## LINCOLN CITY/LANCASTER COUNTY PLANNING STAFF REPORT

**P.A.S.:** Change of Zone #3290 (AGR to R-1)  
Preliminary Plat #02018

**PROPOSAL:** To create 3 residential lots on 3.89 acres located at Old Cheney Rd. & Frontier Rd.

**Preliminary Plat #02018**  
**Frontier Meadows**  
**Frontier Rd. & Old Cheney Rd.**

**FRONTIER MEADOWS  
PRELIMINARY PLAT  
SITE PLAN**

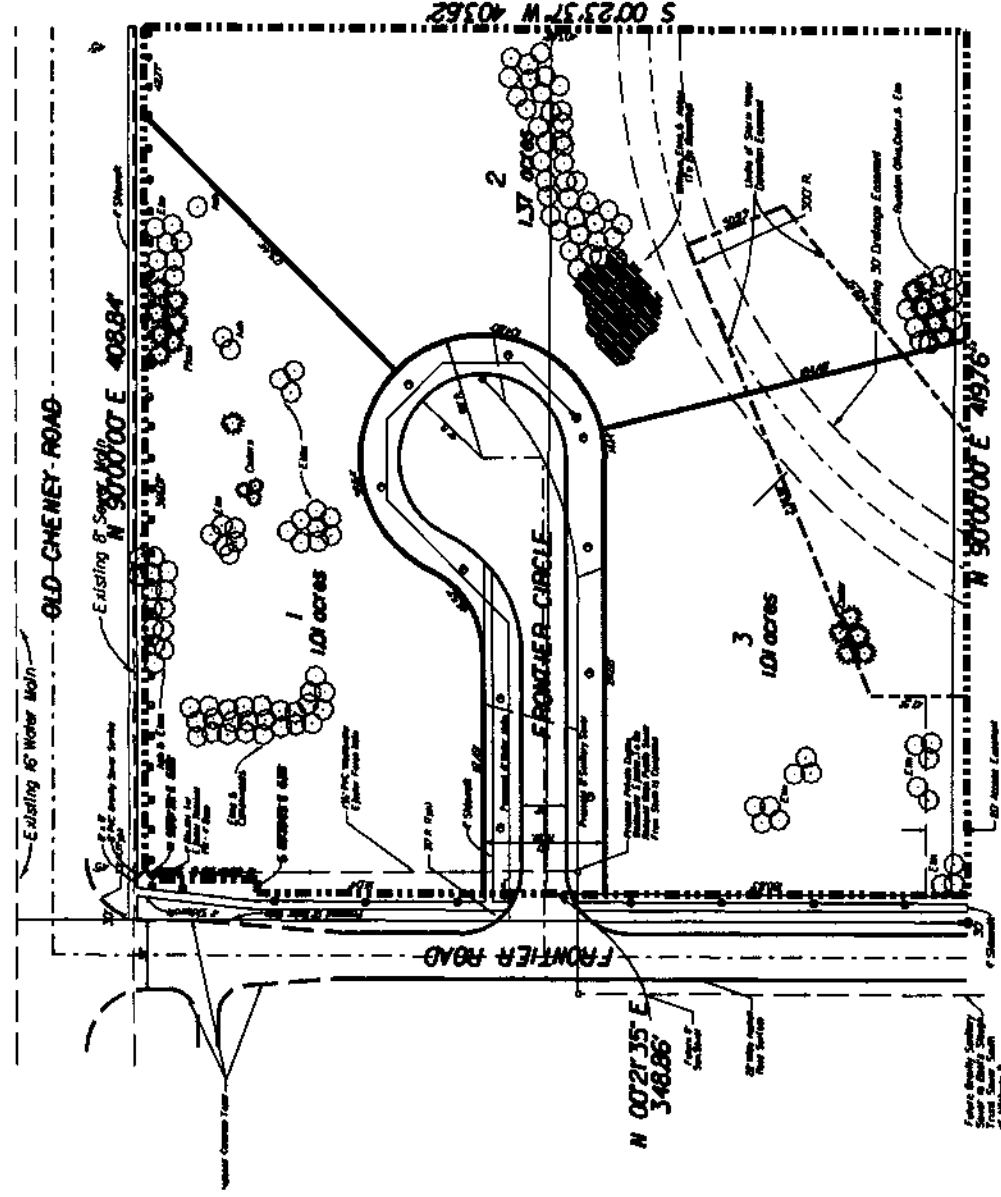
- 1.1.3 Correct the zoning in the notes. The current zoning is AGR and R-1. The requested zoning is R-1.
- 1.1.4 Extend the sidewalk on the north side of Frontier Circle to the east lot line of Lot 1.

- 1.1.5 Show the symbol in the Proposed Street Tree table.
- 1.1.6 Add a note to the site plan stating, "Lots 1 & 2 may be final platted as a buildable lot if the sanitary sewer to service said lots is from Old Cheney Road. Lot 3 may not be final platted as a buildable lot until such time that gravity sanitary sewer is available."

- 1.1.7 Provide landscape screen that meets design standards.
- 1.1.8 Space the street trees according to design standards.
- 1.1.9 Revise the sanitary sewer to the satisfaction of Public Work & Utilities Department.

- 1.1.10 Revise the dam for the detention cell to the satisfaction of Public Works & Utilities Department.
- 1.1.11 Provide a detail showing the necessary erosion control measures for the top and back side of the dam.

- 1.1.12 Revise the grading plan to the satisfaction of Public Works and Utilities Department.
- 1.1.13 Show the existing storm sewer that runs under Old Cheney Rd. at the northeast corner of the plat.

- 1.1.14 Change the sidewalk width to 5' along Old Cheney Rd.
- 1.1.15 As shown on the grading plan, the sidewalk location is shown at the bottom of the roadside ditch. Move the sidewalk out of the roadside ditch.

- 1.1.16 Remove all notes referring to the wastewater ejector.
- 1.1.17 Remove the 11/4" PVC wastewater ejector force main and the note.

1. Water - The water system for this plat is satisfactory.
2. Sanitary - Public Works continues to recommend that the plat be served by a public gravity sewer connecting to the Beals Slough trunk sewer south of Hwy #2 and that the request for waiver of design standards to temporarily use an ejector pump be denied.
3. Grading/Drainage - The dam for the detention cell does not meet design standards (14' minimum top width and 4:1 maximum side slope) and should be revised accordingly. A detail for the outlet structure and culvert needs to be provided, including the velocity and required energy dissipation measures at the outlet.

The entire length of the dam is proposed to be used as the spillway. A detail needs to be provided showing the necessary erosion control measures for the top and back side of the dam. Public Works recommends that the outlet structure be redesigned such that a smaller, more easily maintained spillway is provided.

The drainage ditch on the north side of Frontier Circle at the intersection of Frontier Road does not correspond with the proposed 18" culvert. The grading plan should be revised accordingly.

A portion of the drainage channel running to the proposed pond is outside the drainage easement.

The existing storm sewer that runs under Old Cheney Road at the north east corner of the plat needs to be shown on this plat. The drainage way for the aforementioned storm sewer also needs to be shown on the grading plan with the required easement.

The grading plan does not match the typical cross section shown and should be revised accordingly. Also, the grades along Old Cheney Road do not match new construction and should be revised accordingly.

4. Streets - The developer is requesting rural cross-section roadways with open ditches. Public Works recommends urban type curb and gutter paving. If the rural cross-section is approved over our objection, the developer should be required to maintain the open ditches and culverts. The grading plan should be revised so that the roadways can be converted to urban paving without regrading the lots by showing the grading to meet the potential urban cross-section. This would also allow sidewalks to be built. As shown on the grading plan, the sidewalk location is shown at the bottom of the roadside ditch. This location is unsatisfactory for routine maintenance and snow removal.

The sidewalks along Old Cheney should be 5' in width to meet ADA requirements.

1. Please provide label/symbol of tree species in the plant table as to how they correspond with the numbers located on the plan.
2. Street trees which are large overstory species need to be planted at a maximum of 60' on and a minimum of 45' between trees.
3. Street trees which are flowering or ornamental need to be planted at a maximum of 45' on center and a minimum of 20' between trees

Please distinguish between the street trees required by the City and the Screening trees required by the City. Street trees do not count towards the screening requirement.

4. As stated in the September 17<sup>th</sup> Memo, a more effective screen is created by staggering trees and creating groups than one continuous line of alternated trees. Please consider this in designing a street screen.
